191226000-2021

COUNTY OF BECKER

Re Property: 19.1226.000

Brief system description: lift station to 1500 gal septic tank with rockbed drainfield

Indicate depths or elevations

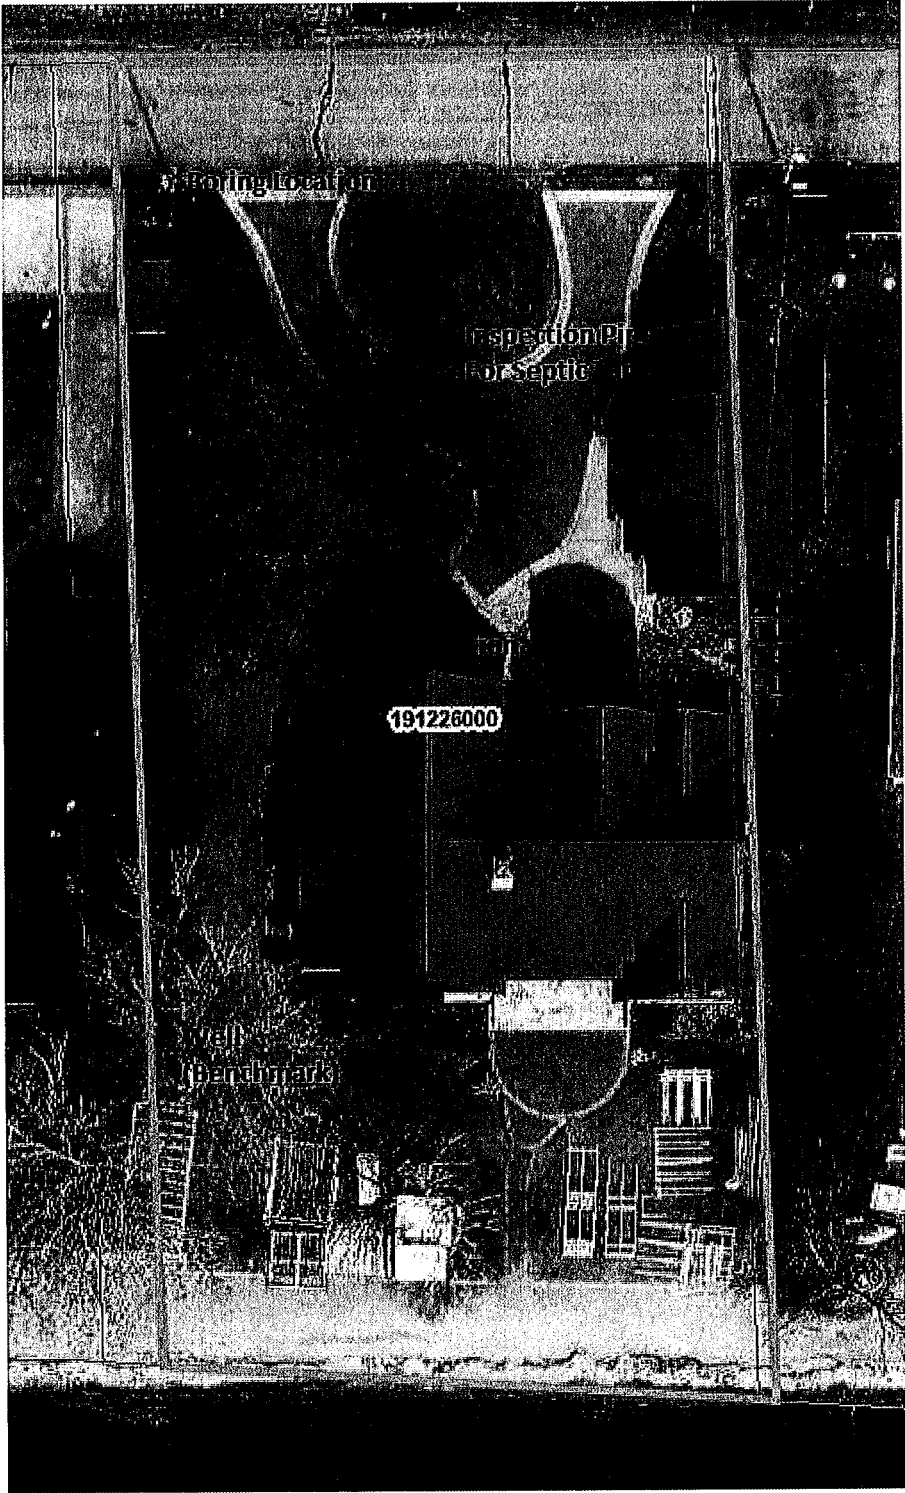
System is non-compliant because it doesn't have enough soil separation.

A. Bottom of distribution media	97' 10"
B. Periodically saturated soil/bedrock	96' 8"
C. System separation	14"
D. Required compliance separation*	32"

The system could be converted to a holding tank. A pressure bed may also be an option but further soil borings would be needed to confirm there would be enough soil separation.
